Date: January 26, 1990
To: Mark Seemann, Building & Zoning Official
From: Larry Heath, Director of Public Works
Re: Granada Avenue Property - Parking Lot Improvements

To: Planning Commission
From: H.M. Place, Director of Planning
RE: Petition 90-1SE (City Hall Parking Lot)

PRELIMINARY
NOT TO BE USED FOR CONSTRUCTION
GRANADA AVENUE

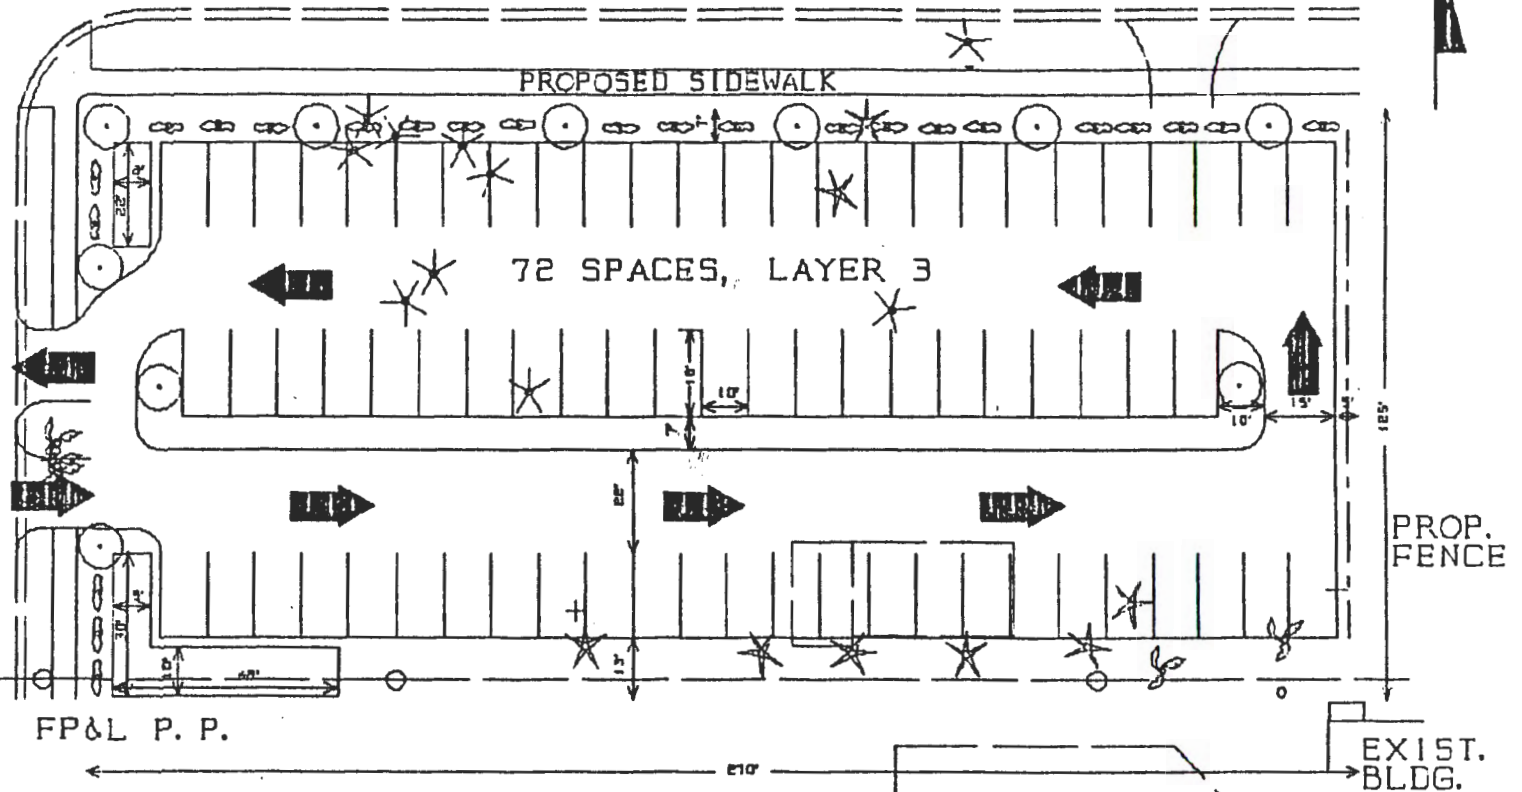
Attached for reference, is a preliminary site plan of a proposed parking lot which we have reviewed with Planning and Building & Zoning, for possible consideration of construction. This plan shows approximately 72 parking spaces but might have to be reduced to approximately 68 to avoid the removal of two good-sized oak or elm trees. The trees are too large to move to another location, therefore, we will forfeit spaces in saving the trees.

The estimated cost of construction, based on this preliminary plan is \$87,400.00. In reviewing an alternate consideration, the Southern portion of the parking lot has one row of stalls totalling approximately 25 spaces. If hard surface is eliminated for this portion and sod is installed for temporary overflow parking, the projected savings would be around \$4,000.00.

1. The lot will not be restricted to day time usage. It will be available for evening meetings at City Hall and adjacent residents have been assured they will be able to use the lot at night.
2. No lighting is planned in the initial construction, but in the event they are installed at a later date, they will be low profile lights so they will not shine on neighboring properties.
3. The City Manager will be requesting sufficient funds from Council to pave the entire lot per the site plan rather than leaving any area grassed for reserve parking.
4. The total number of spaces will be determined at the time working engineering drawings, however, the probable maximum number will be 72 as per the site plan.

SOUTH BUFFER MUST HAVE
6' HIGH PLANTS OR FENCE
PLACED 3' INSIDE OF LOT
LINE WITH PLANTINGS 10'
APART ON THE PROPERTY
LINE SIDE.
